10 B0100009

SB, 235 R, Bevel gear, 2001-02

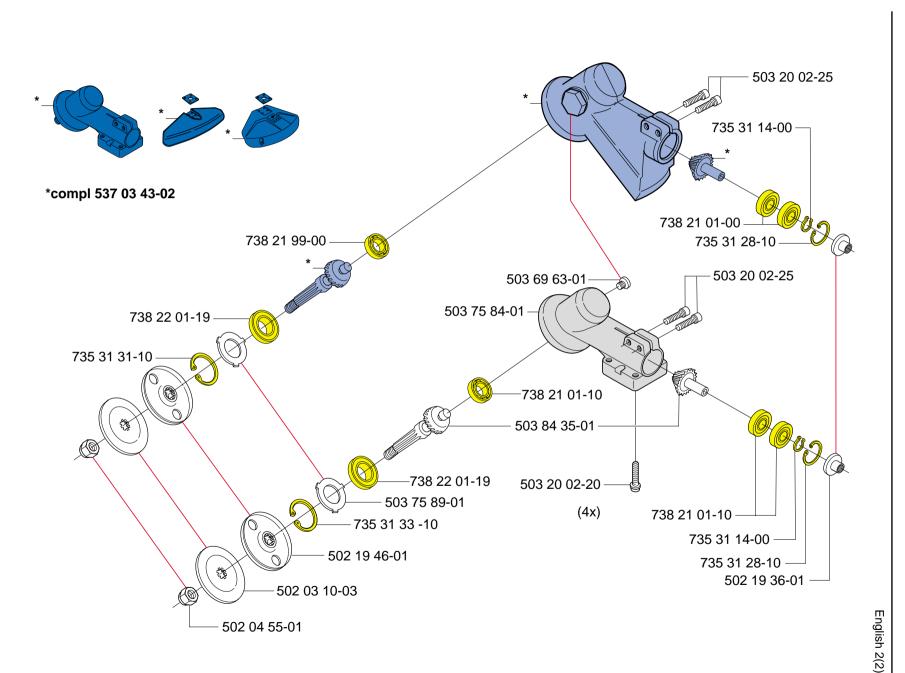
The earlier bevel gear (502 18 50-01 assy.) for the 235R is no longer available as a spare part. Similarly, the gear housing 531 00 20-01 and gearwheel kit 503 84 35-01 for this bevel gear have been discontinued.

In recently manufactured machines the bevel gear, 502 18 50-01, was replaced a couple of years ago by the current bevel gear, 503 75 83-01. This bevel gear has a different type of mounting for the spray guard. This means that customers who have the old guards will not be able to fit them to the current bevel gear.

As for the other parts in the earlier bevel gear, the following applies. (See diagram). Earlier bevel gear is at the top.) All parts marked with a dash are fully interchangeable between bevel gears. The remaining parts are standard parts, such as ball bearings, sealing rings, etc. These are still available as spare parts.

We have therefore produced a kit, ref. no. 537 03 43-02, which, in addition to the bevel gear, contains two spray guards: one for a trimmer head and the other for a grass blade.

Bevel gear assy. 502 18 50-01, gear housing 531 00 20-01 and gearwheel kit 503 84 35-01 have therefore been replaced by the current bevel gear 503 75 83-01 which includes two spray guards. The article number of this kit is 537 03 43-02.
